NOTICE OF MEETING
PLANNING AND ZONING COMMISSION
6:00 P.M. – July 16, 2020

PLANNING AND ZONING COMMISSION ITEM:
PC-20-08
FINAL PLAT
4S RANCH, UNIT 7C

SUBJECT: 4S Ranch, Unit 7C Final Plat Acceptance
 PC-20-08

REVIEW MEMORANDUM

**SUBDIVISION PLAT
OF
4S RANCH, UNIT 7C**

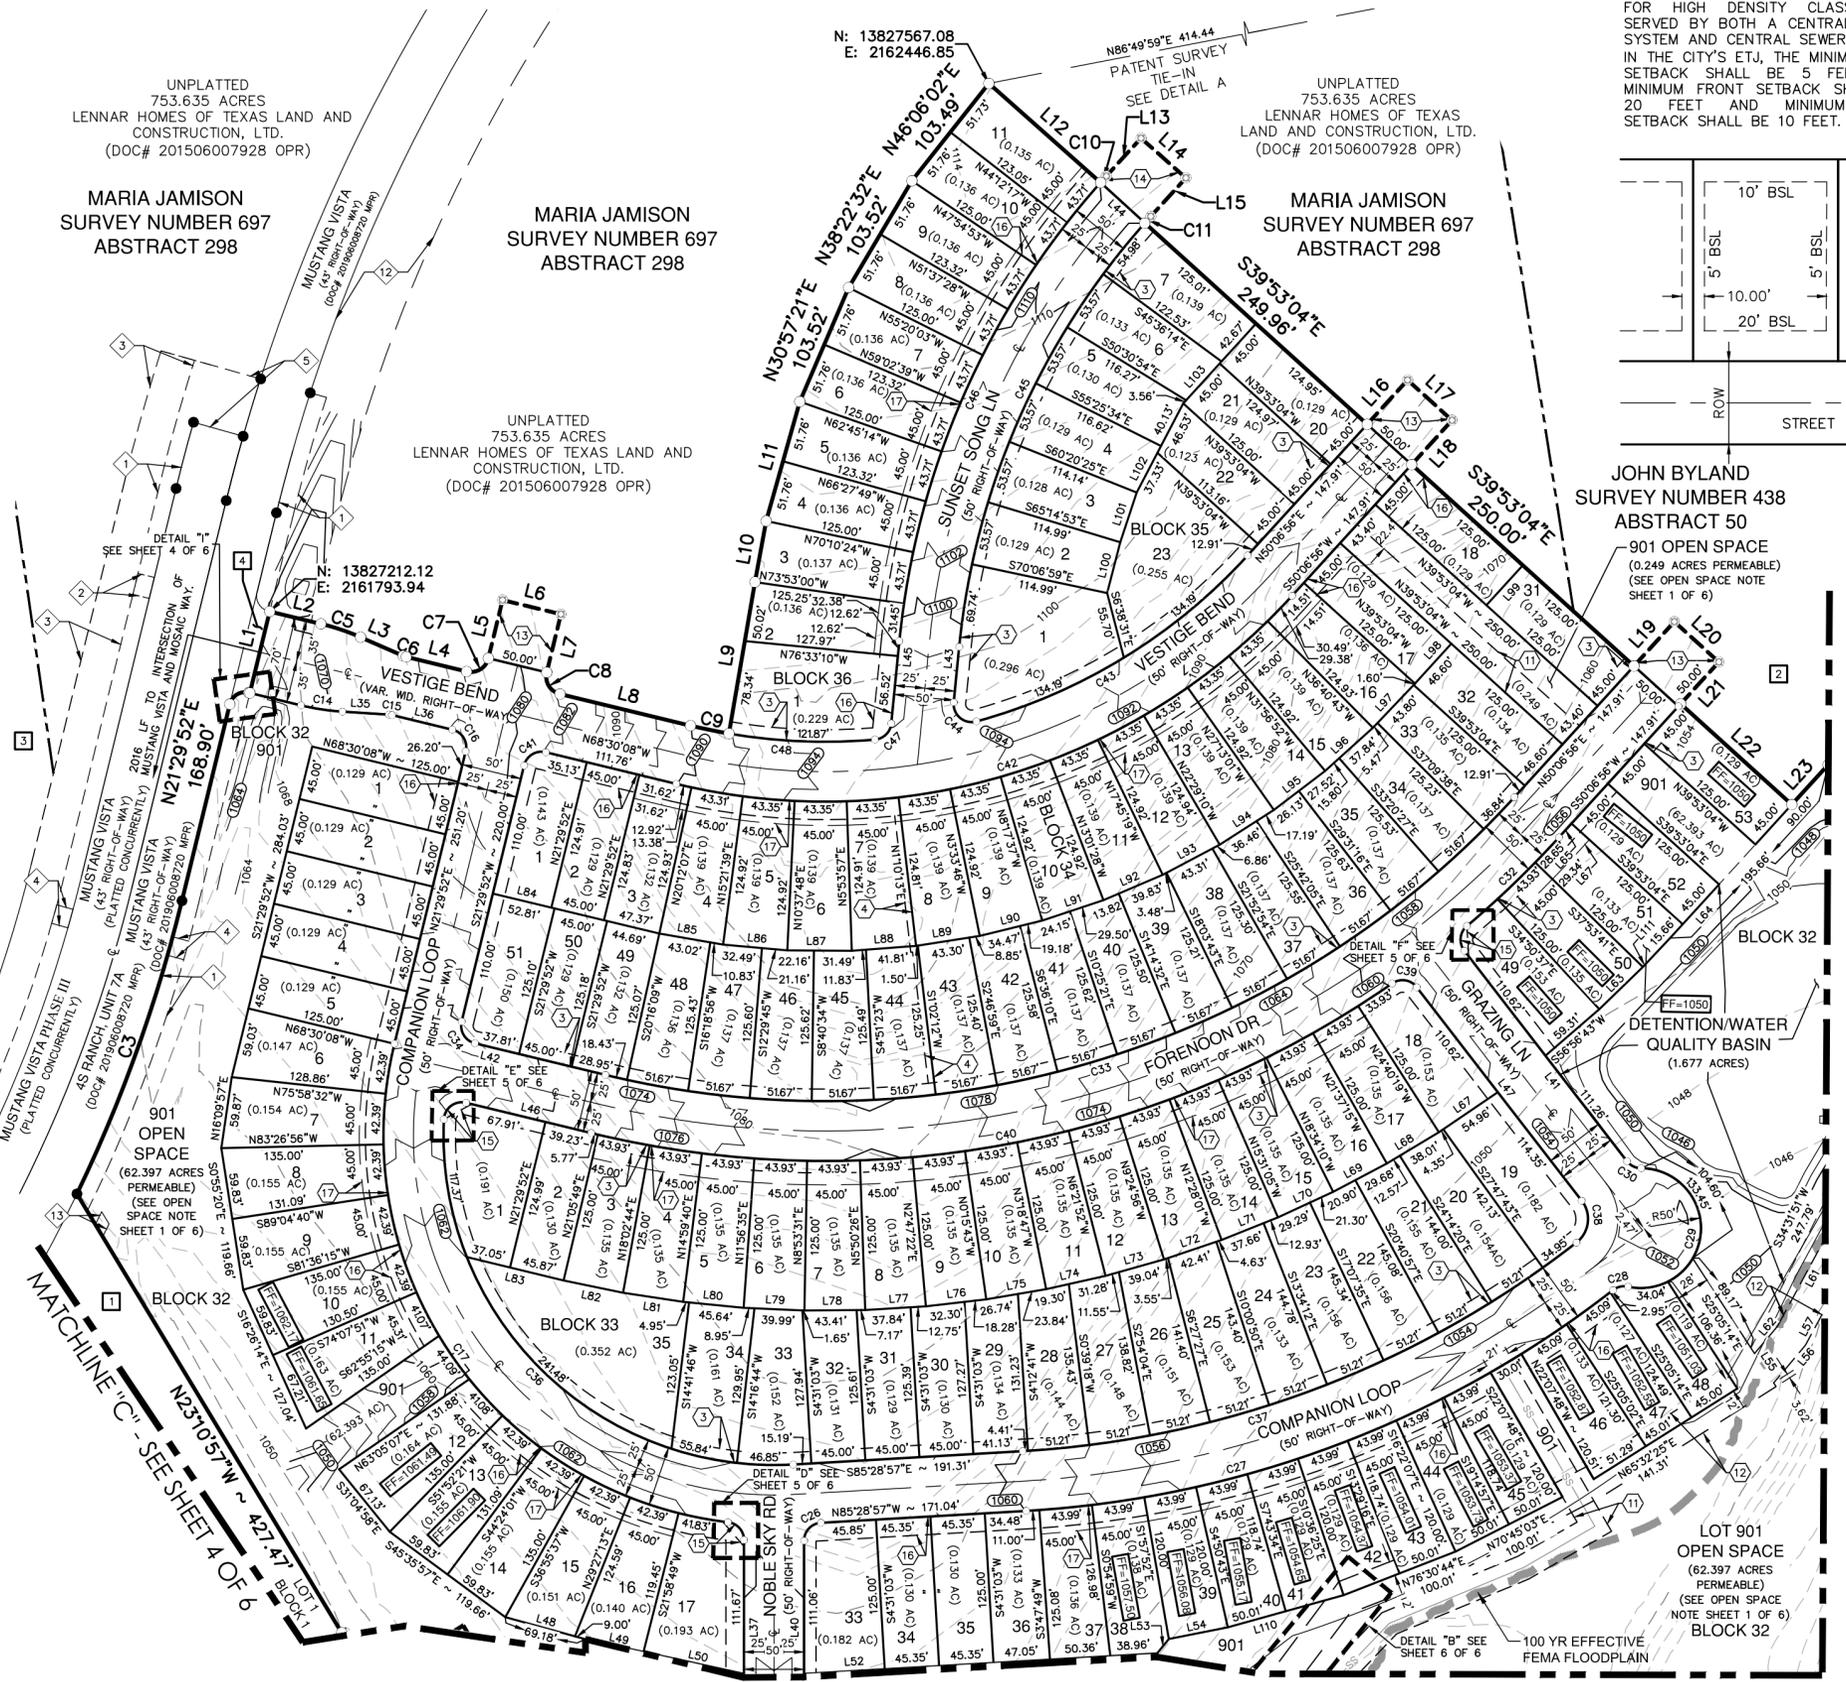
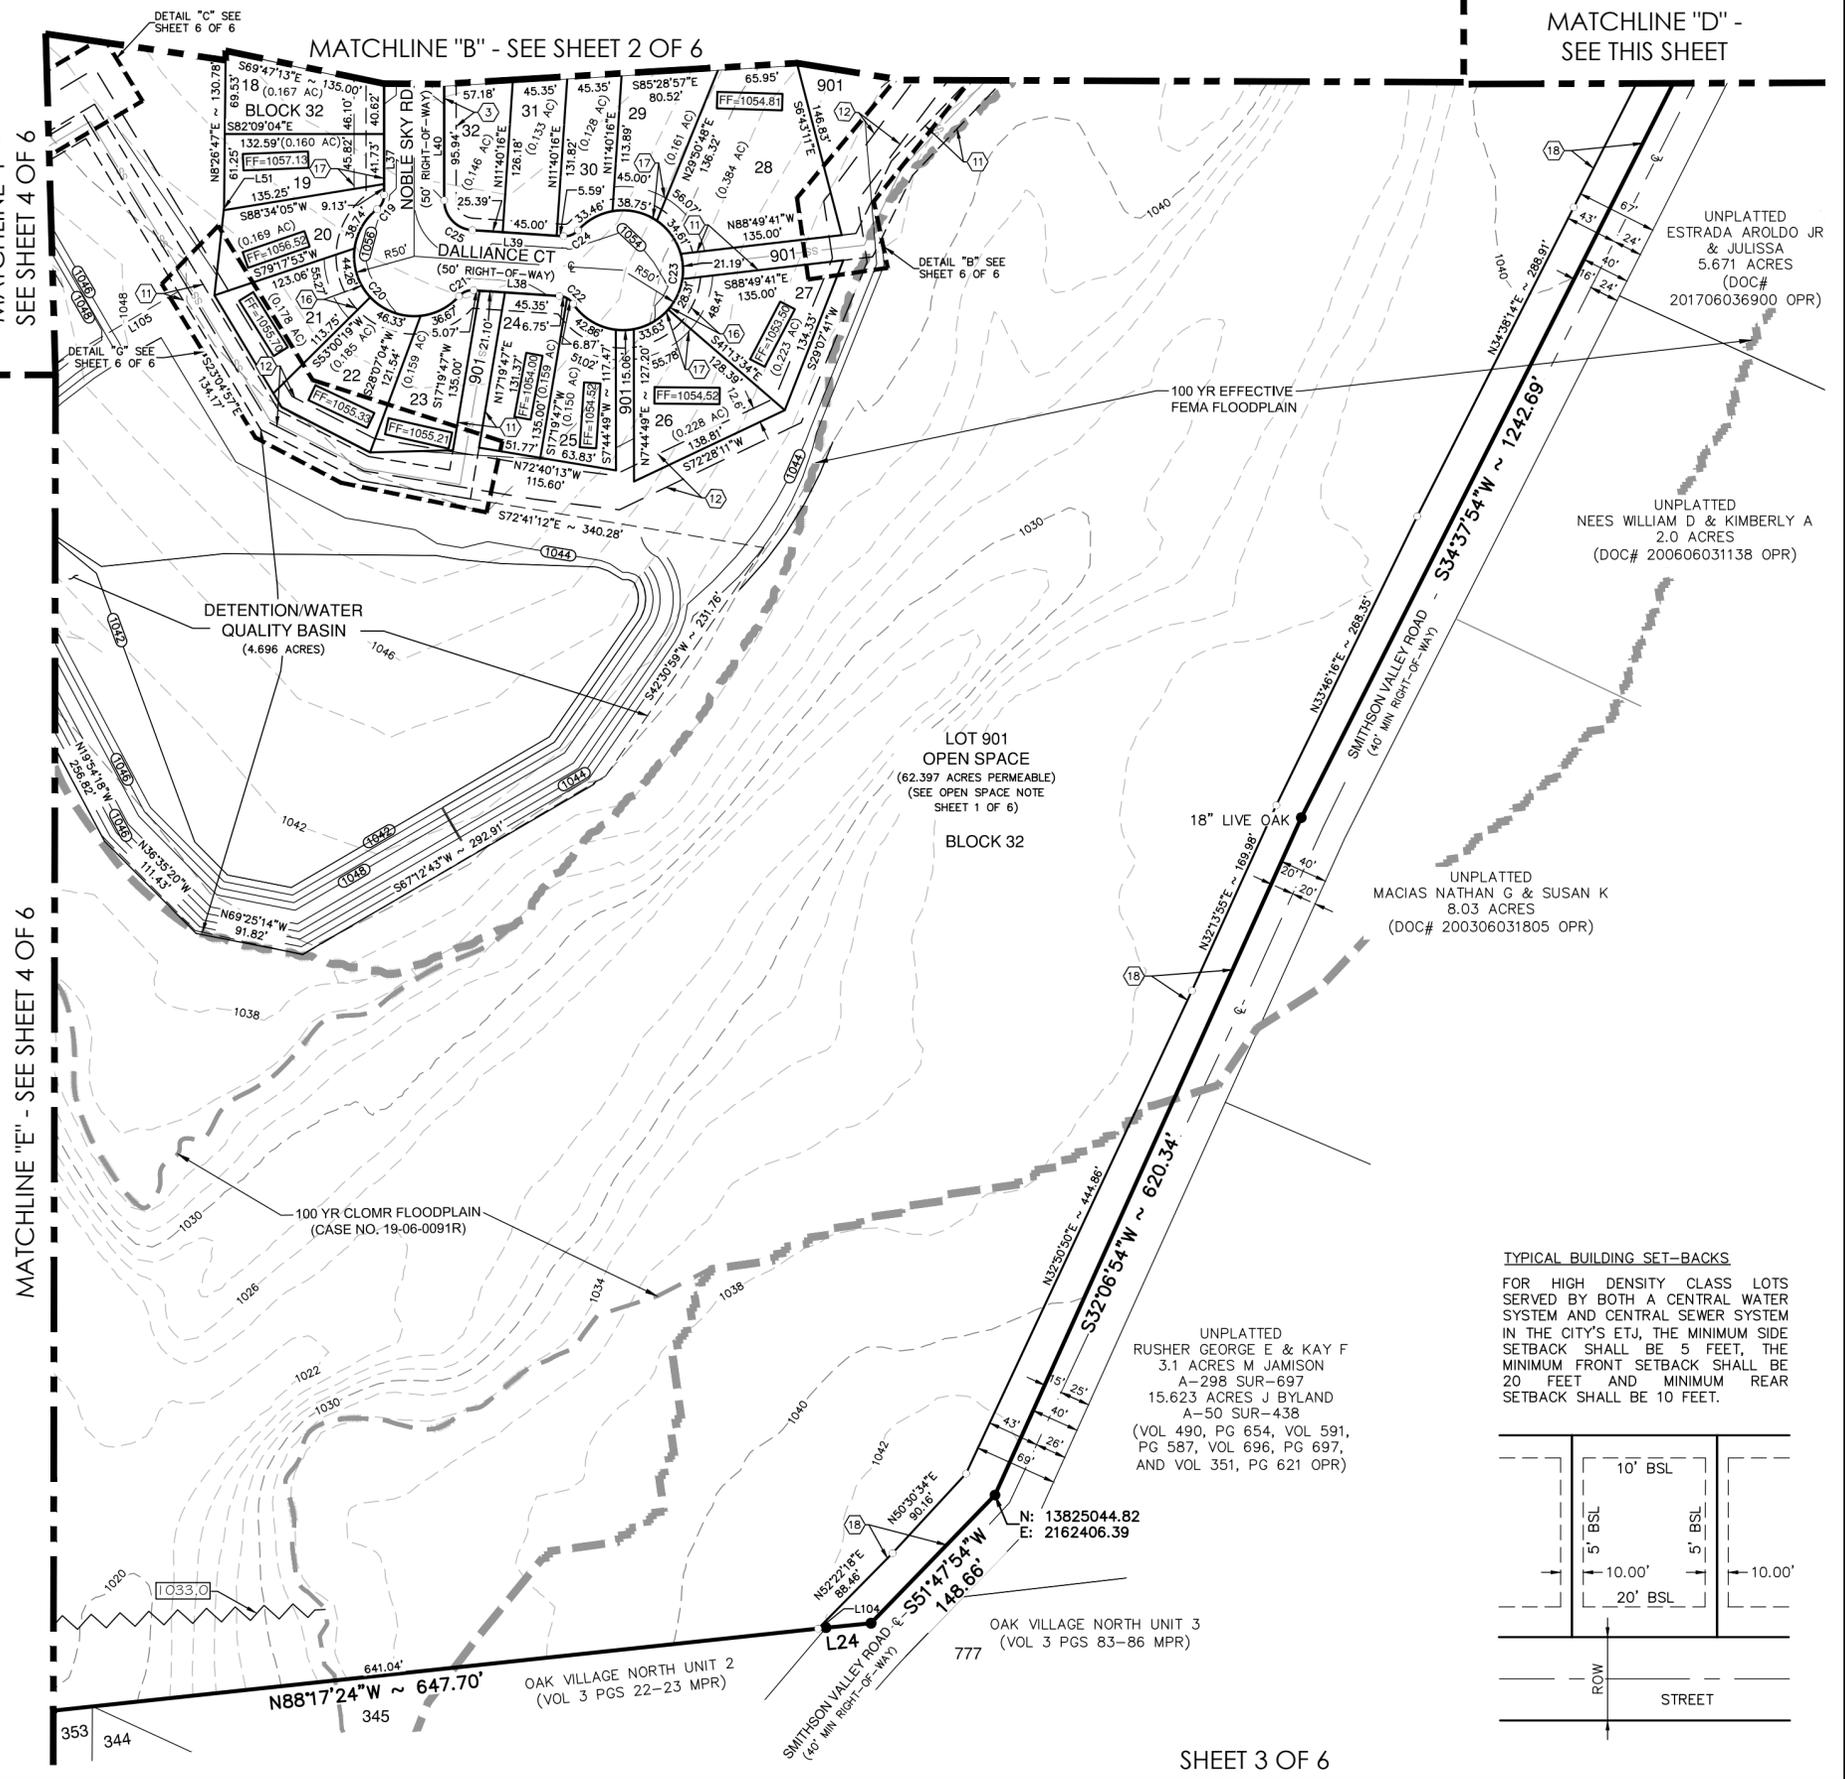
- Legend on several sheets refers to Mustang Vista Phase 3 being platted concurrently. This plat was recommended for approval on June 28, 2019. Please include the Doc # similar to other easements in the legend. – *Comment withdrawn...although already accepted by P&Z, the Mustang Vista Phase III plat has not yet been recorded. No document number is available and the 'PLATTED CONCURRENTLY' text is still appropriate.*

Response: Please note that although accepted by P&Z, the Mustang Vista Phase III plat has not yet been recorded. Therefore, no document number is available for the plat. The 'PLATTED CONCURRENTLY' text is to be replaced upon recordation of the plat.
